Raidha Collections Ltd.

Zamirdia, Valuka, Mymensingh, Bangladesh

25 June 2014

Observations

Main Factory Building – Column Layout

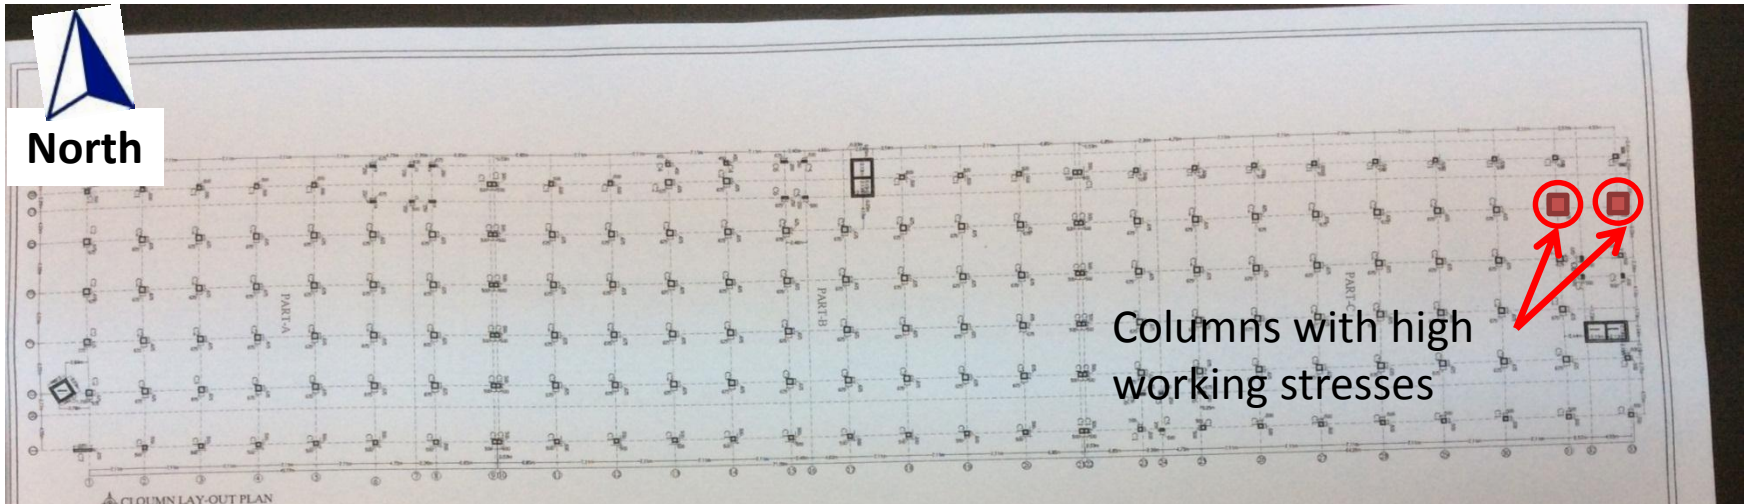
Testing of columns confirmed Stone aggregate.

Cursory calculations indicate that working stresses exceed normal acceptable levels in the columns supporting the toilet block.

Building Engineer to perform detailed calculations based on “as built” dimensions and loadings. Material data from concrete tests to prove column strength.

**Structural drawings not consistent with the
as-constructed arrangement of the factory**

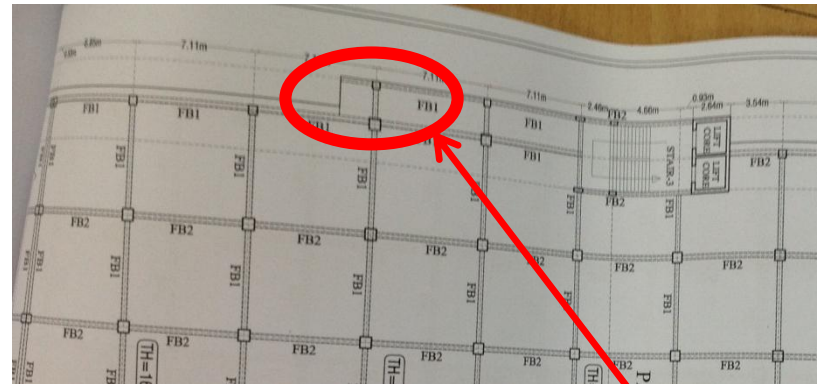
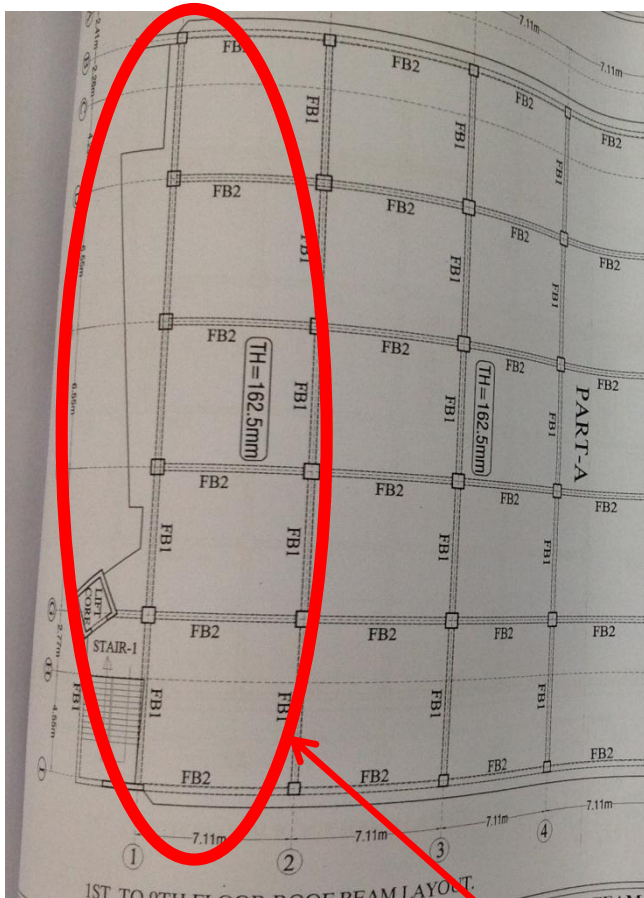
Cantilever beam indicated on the drawings not provided

Cantilever Beams provided not indicated on the drawings
